Access Compliance Report

Public Rights-of-Way

(Curb Ramps)

Intersection ID: 32254	Main Street: BALLANTYNE_CROSSING_AV	Cross Street: BALLANTYNE_GLEN_WY	Location: W
ADA ID: 9543922F9B76	Ramp Type: Perp	Initial Pass/Fail: Fail	Overall Compliance: No
Severity Score: 13.75			
Codes/Mitigation Info/Possible Solution		Field Measurements/Component Compliance

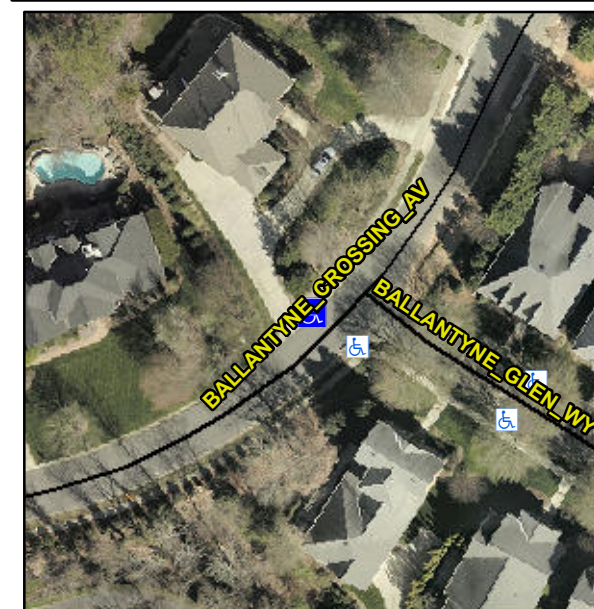
Not Found, R304.2.2, R304.5.3

Compliance	Description	Data	Compliance	Description	Data
N/A	Ramp Length (in)	50.0	No	Ramp Slope (%)	9.2
Yes	Ramp Width (in)	48.0	No	Ramp XSlope (%)	3.9
N/A	Flare Type LT	N/A	N/A	Flare Type RT	N/A
N/A	Flare Slope LT (%)	N/A	N/A	Flare Slope RT (%)	N/A
N/A	Flare Traversable LT?	N/A	N/A	Flare Traversable RT?	N/A
N/A	Landing Length (in)	N/A	N/A	DWS Provided?	N/A
N/A	Landing Width (in)	N/A	N/A	DWS Contrast?	N/A
N/A	Landing Slope (%)	N/A	N/A	DWS Length (in)	N/A
N/A	Landing X Slope (%)	N/A	N/A	DWS Full Width?	N/A
N/A	Landing Curb? (Y/N)	N/A	N/A	DWS Offset (in)	N/A
N/A	Shared Landing?	N/A			
N/A	Gutter Ponding?	N/A	N/A	Gutter Slope (%)	N/A
N/A	Gutter Lip Ht (in)	N/A	N/A	Gutter X Slope (%)	N/A
N/A	Painted X Walk1?	No	N/A	Painted X Walk2?	N/A
	X Walk 1 Direction	To SE		X Walk 2 Direction	N/A
N/A	X Walk 1 Width (in)	N/A	N/A	X Walk 2 Width (in)	N/A
	X Walk 1 Slope (%)	2.4		X Walk 2 Slope (%)	N/A
	X Walk 1 X Slope (%)	0.8		X Walk 2 X Slope (%)	N/A

Remove & Replace Entire Ramp.
